ROUTER

FIELD CHANGE NOTICE

PRODUCT: CMI / MFX

ASSEMBLY No. ESPRT1 DESCRIPTION ROUTER

Title: ESP-R12 - HPF and Control Logic
 Doc: Document Number: R12CON_SCH
 Date: June 9, 1991 Sheet 1 of 2

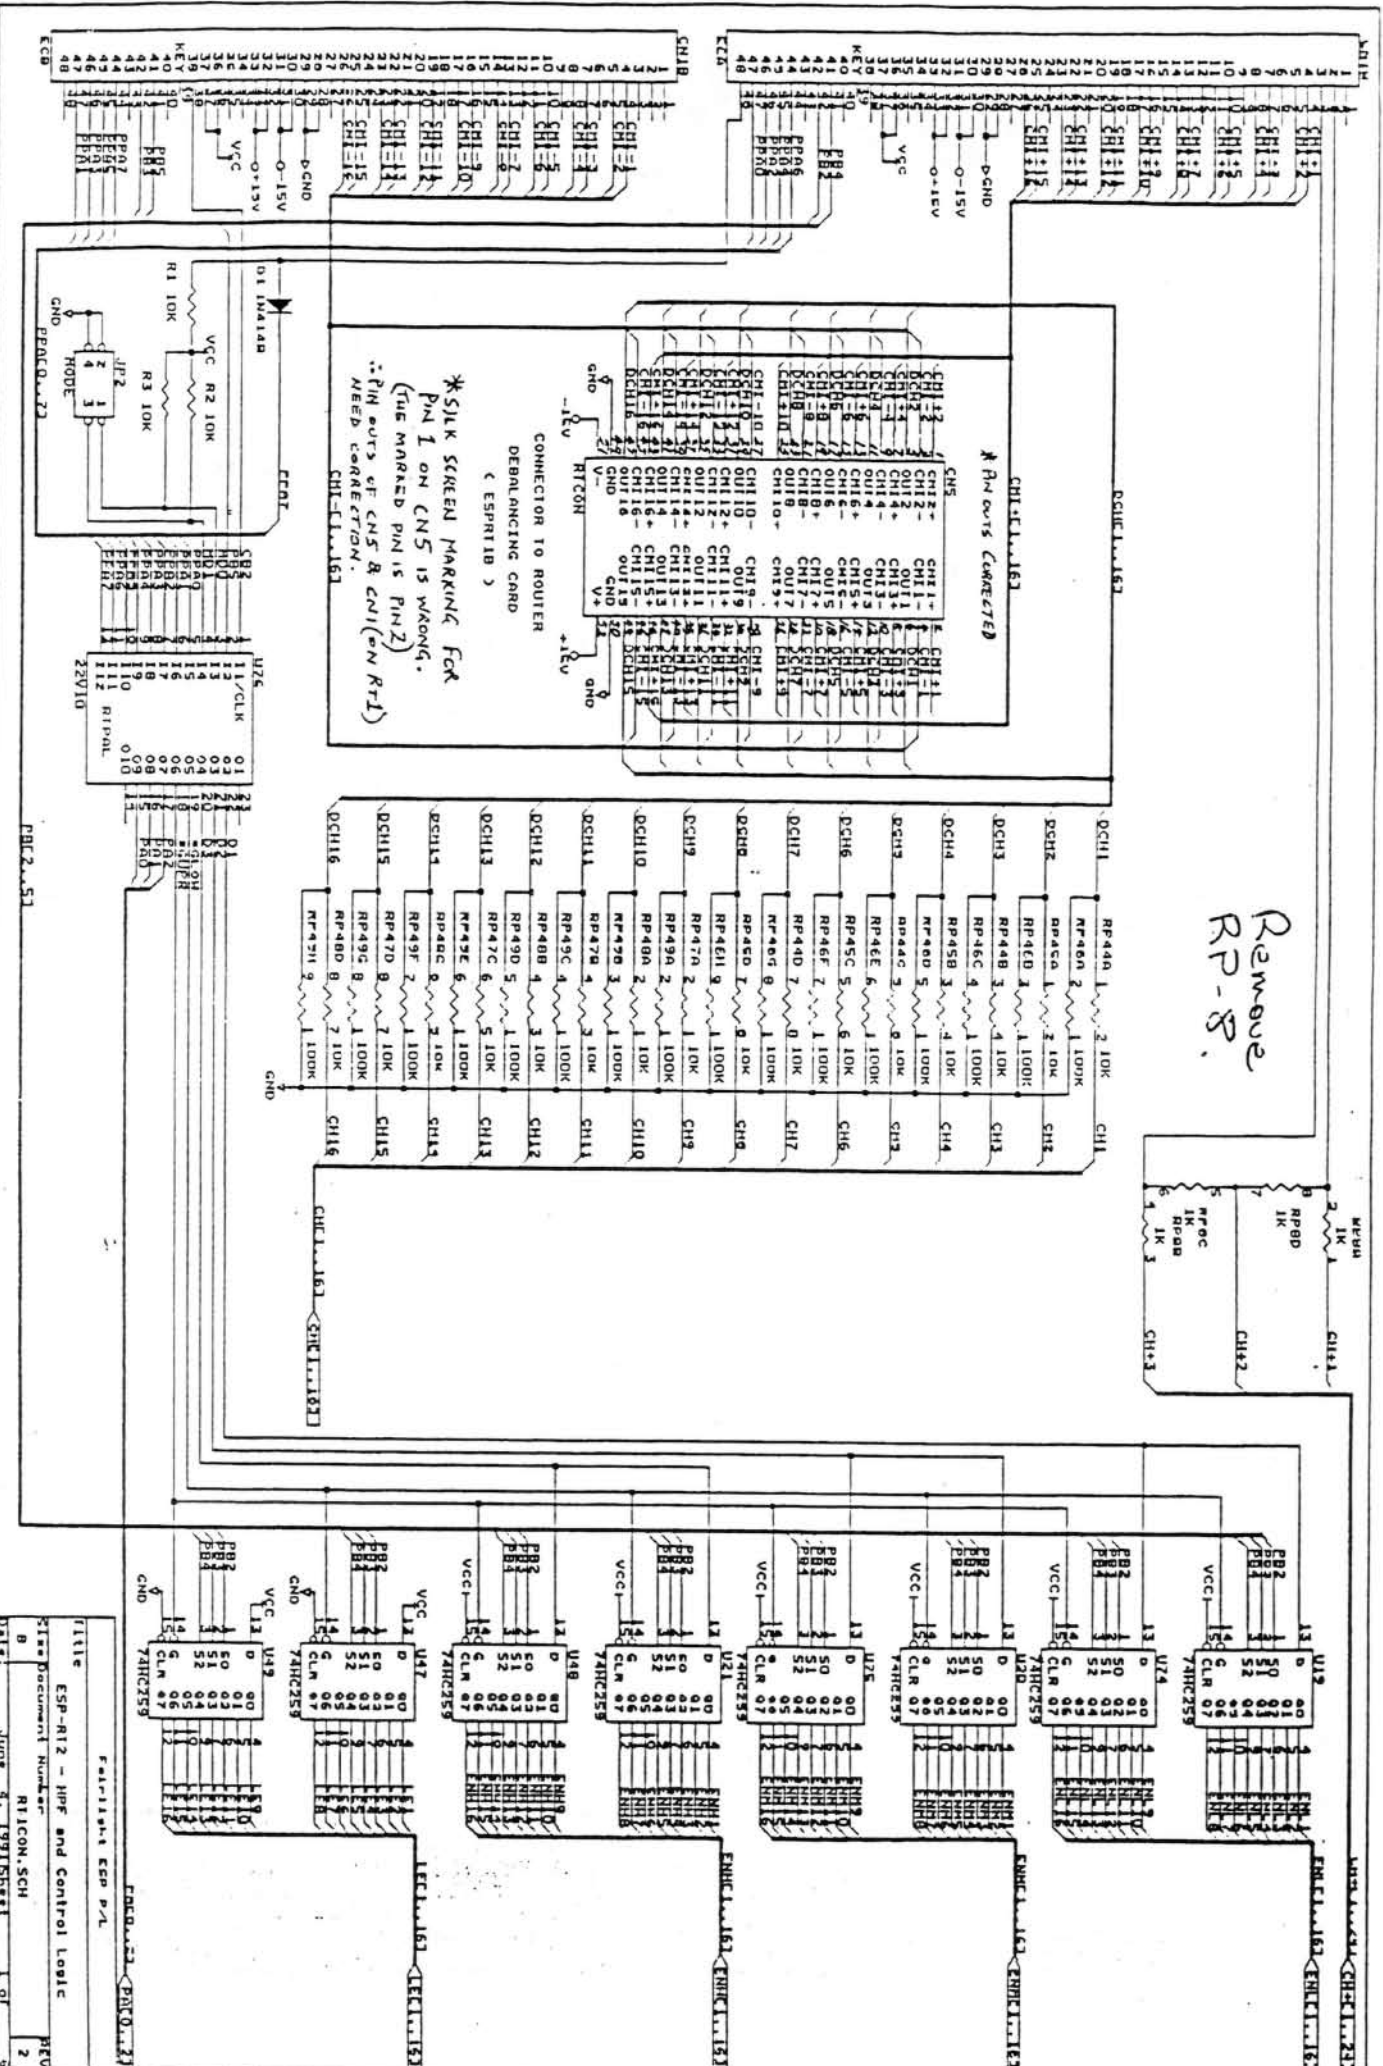
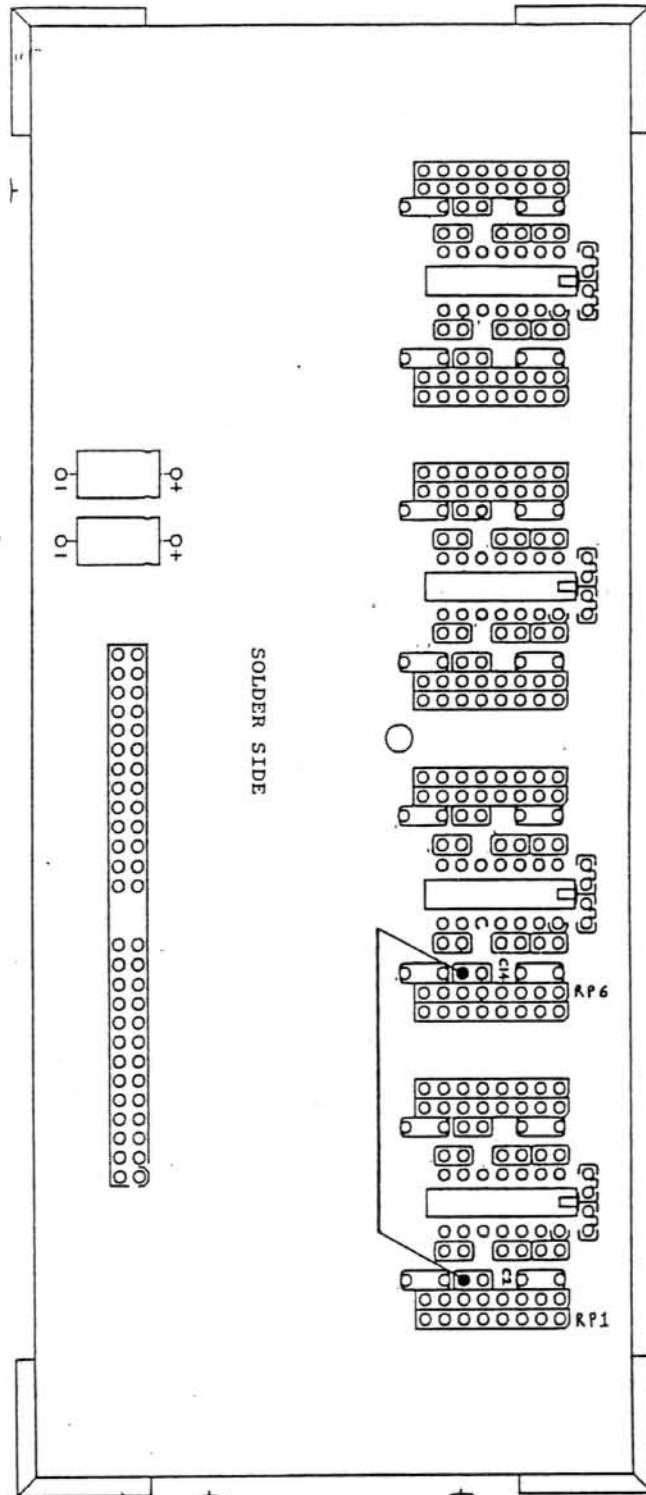
REASON FOR CHANGE:

Removal of headphone mixing resistors.

This modification removes crosstalk between outputs 1, 2, 3 in units with NO headphone amplifier.

1. Remove resistor pack RP-8 (1K ohm)
2. Mark PCB as REV 2.1.

Title	Fairlight ESP p/L
File	ESP-RTIB DIFFERENTIAL AMPLIFIERS
Size	Document Number
Rev	B
Date	June 17, 1991
Page	2 of 2

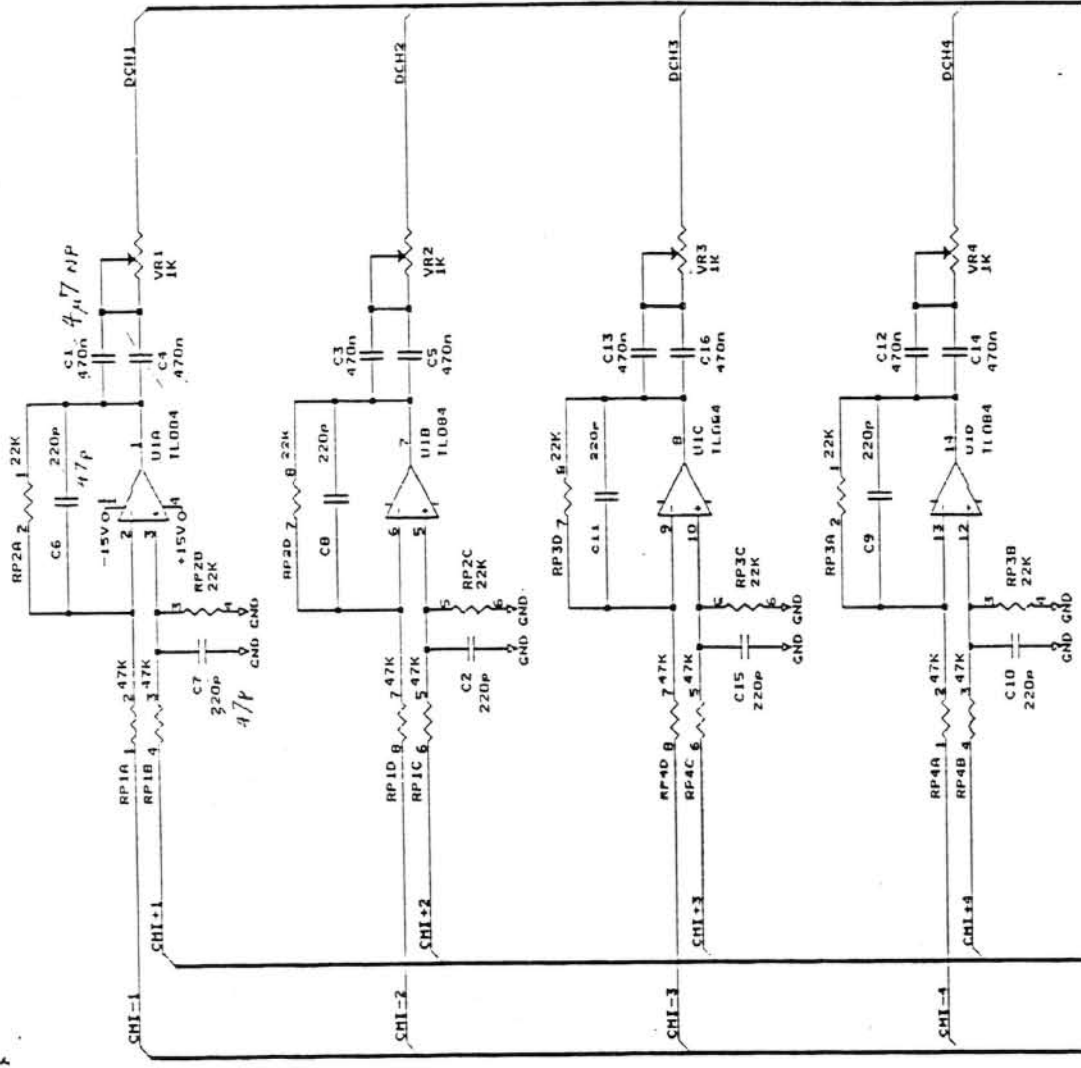
* CHANGE TO
CAP. VALUES ...
- DISTORTION...
47K R. PACIS
MADE IN 8909
ARE DUDS!
ALSO SOME 9232's

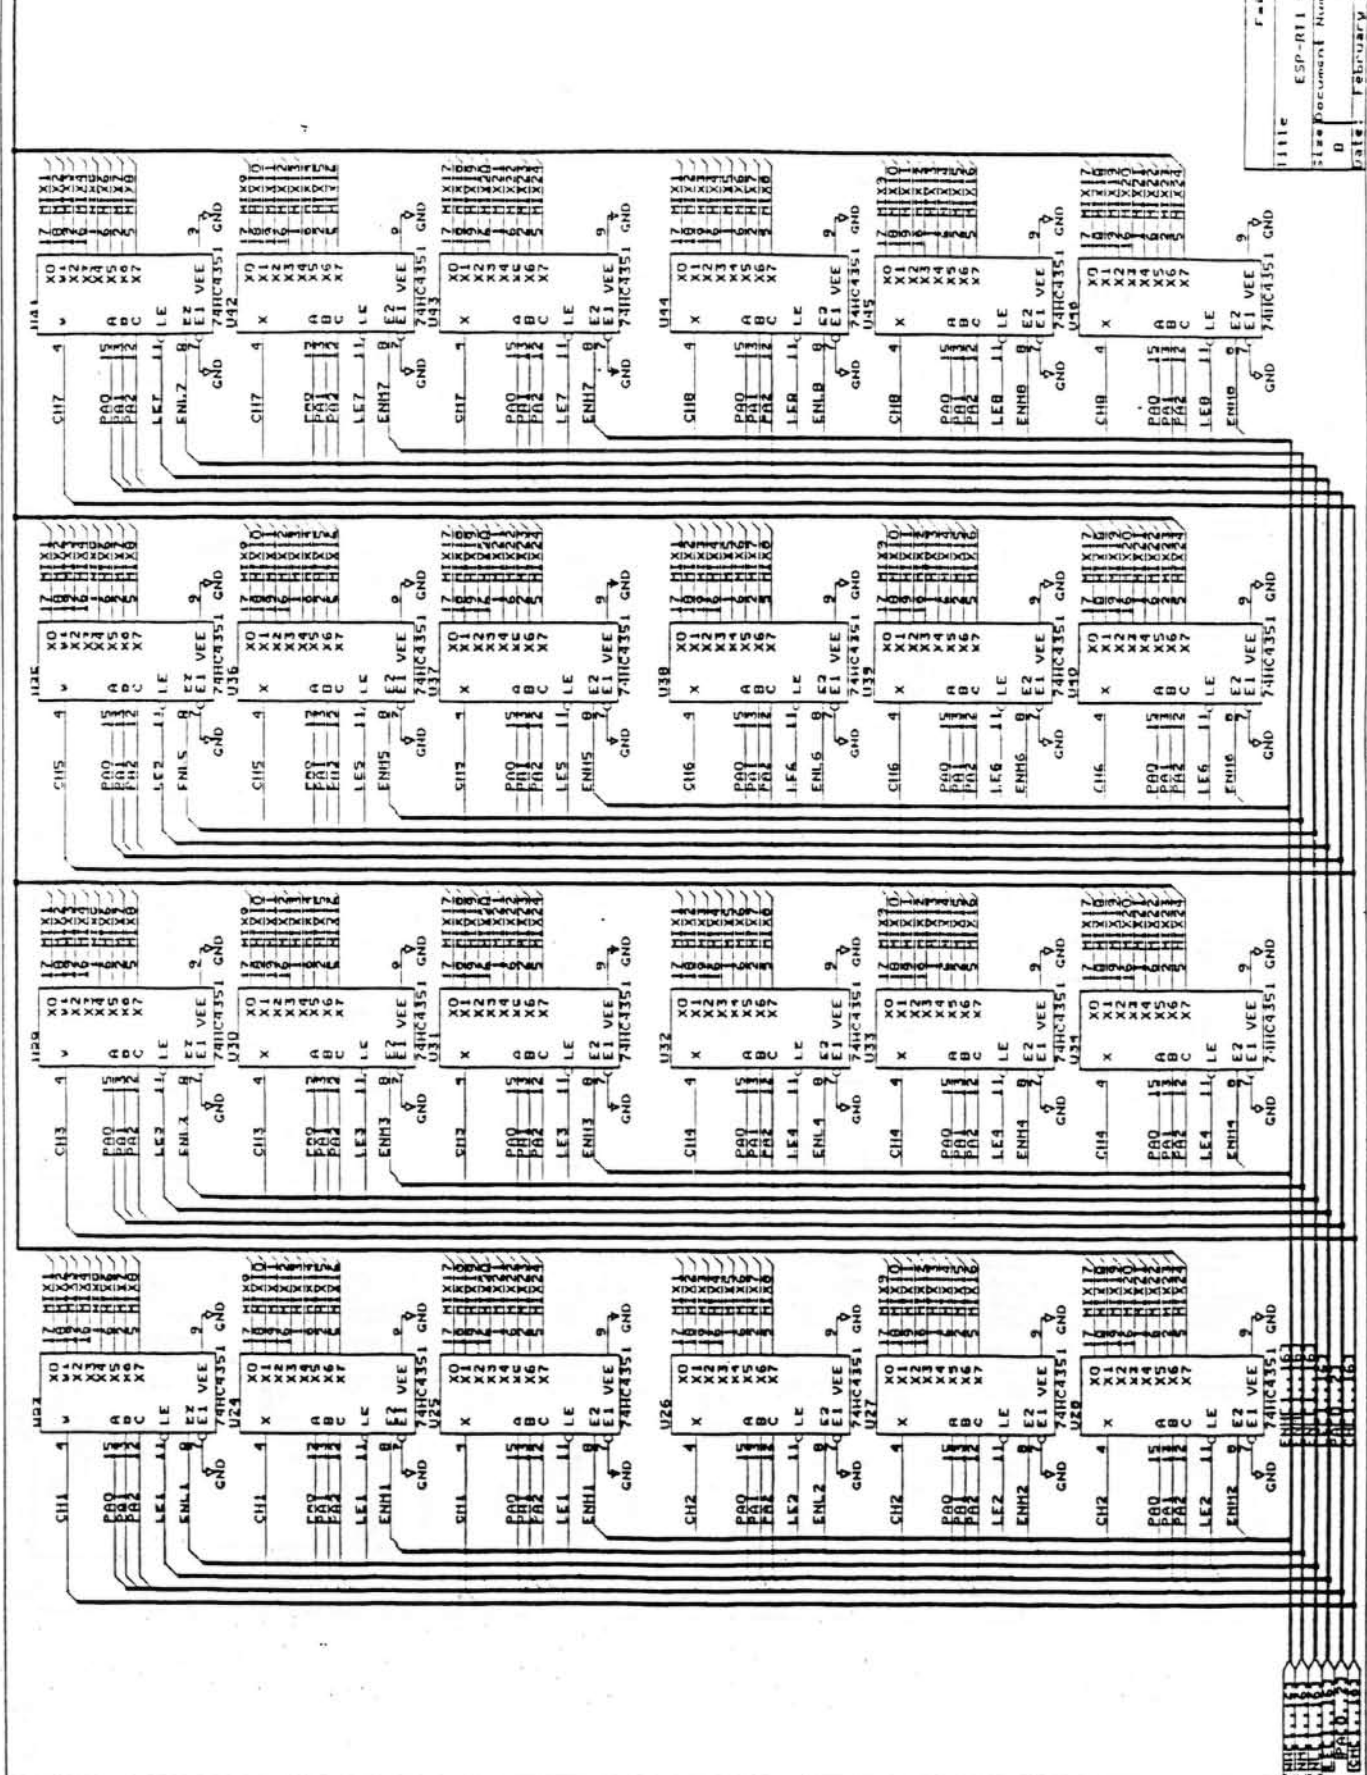
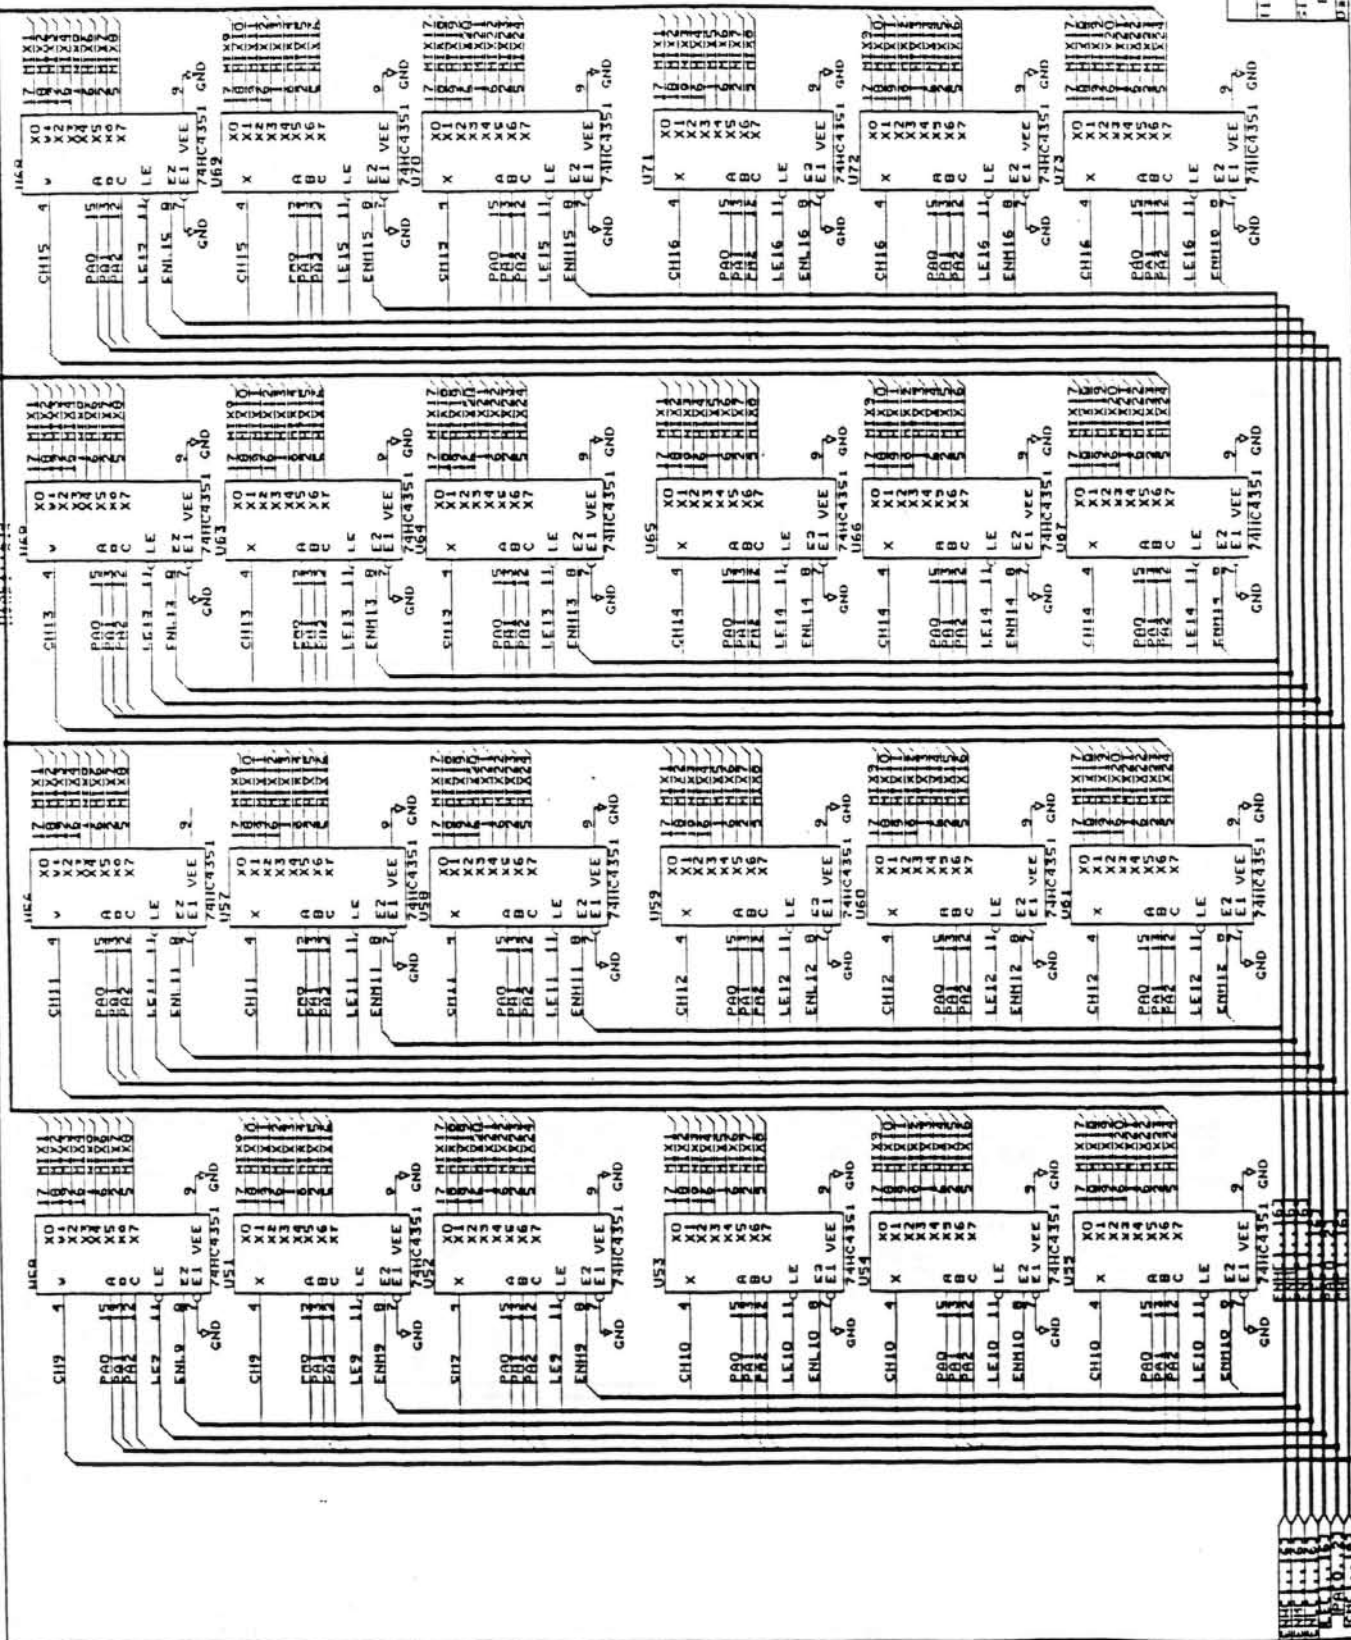
*SILK SCREEN MARKING FOR
 PIN 1 ON CNS IS WRONG.
 (THE MARKED PIN IS PIN 2)
 **PIN OUTS OF CNS & CNI(EN RTI)
 NEED CORRECTION.
